Subject: UniStar Nuclear Energy, NRC Docket No. 52-016
Response to Request for Additional Information for the
Calvert Cliffs Nuclear Power Plant, Unit 3,
RAI 280, Internal Flooding

**Updated Response to NRC Request for Additional Information
RAI 280, Question 10.04.05-5, Internal Flooding**

Calvert Cliffs Nuclear Power Plant, Unit 3

Figure 10.4-1 - { Circulating Water System P&ID (Circulating Water Pump Building)}

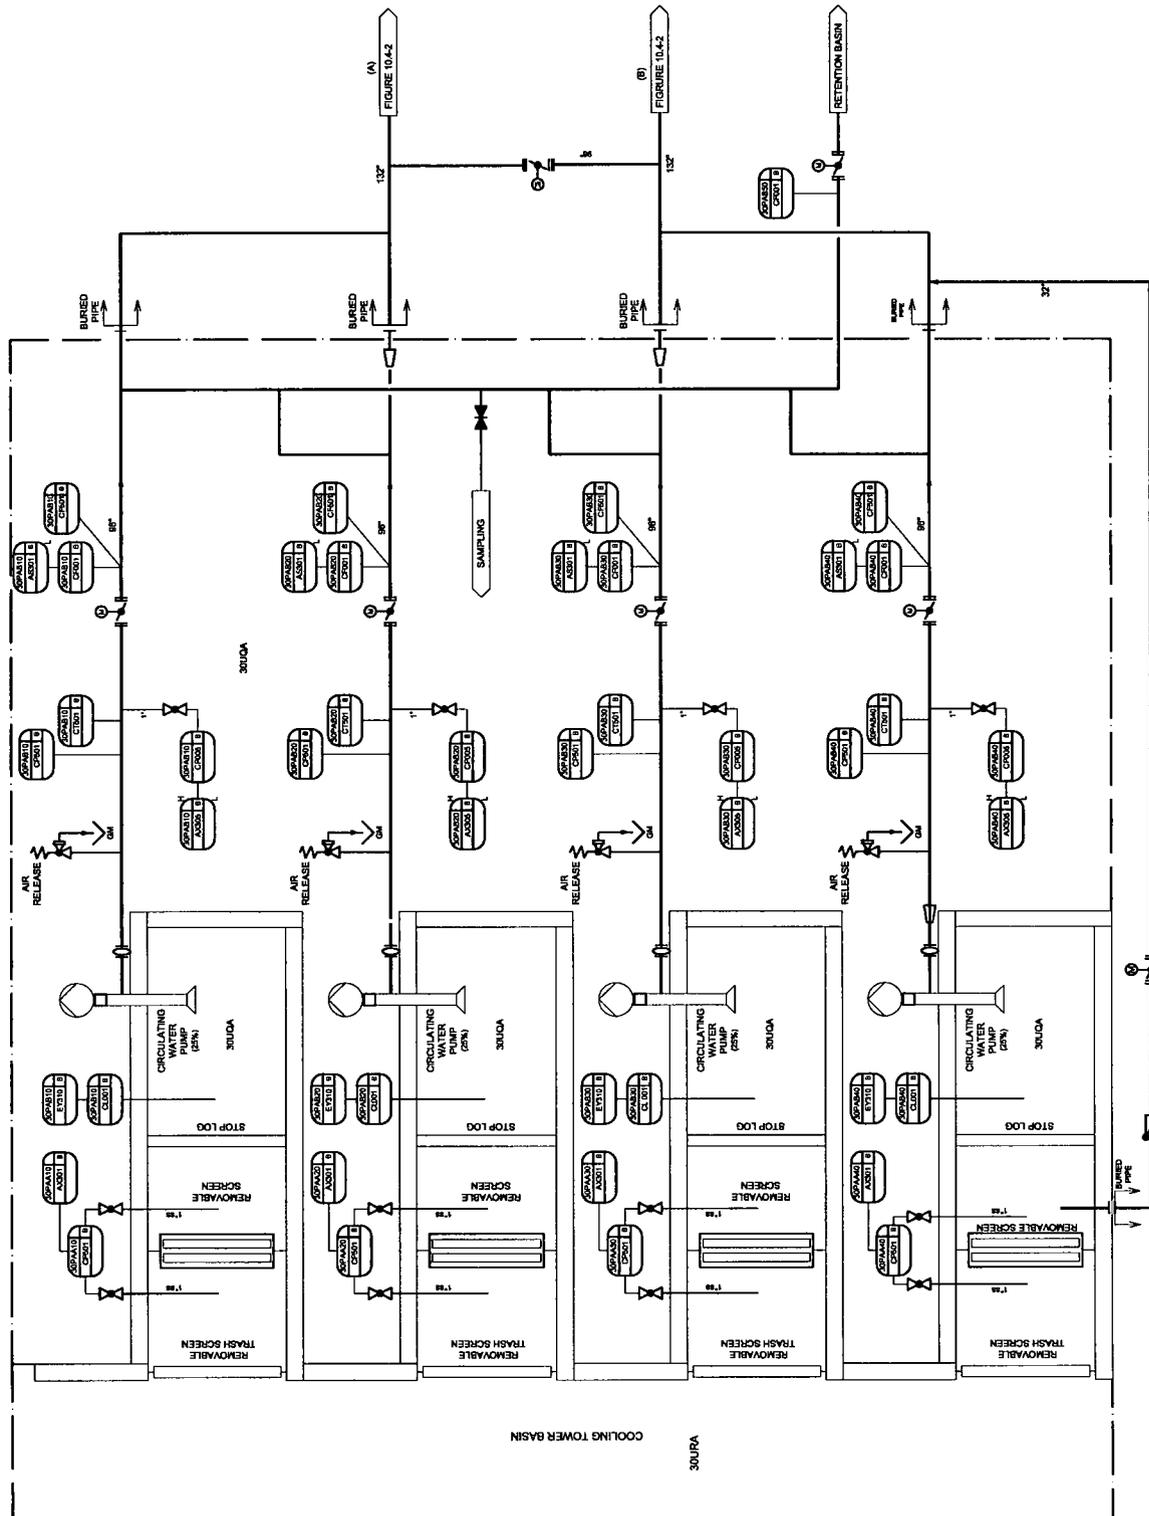
Also, FSAR Figure 10.4-1 (Circulating Water System P&ID – Circulating Water Pump Building) has been updated to reflect the design configuration consistent with RAI 246, Question 10.04.05-4¹ response.

FSAR Figure 10.4-1 is replaced with the following:
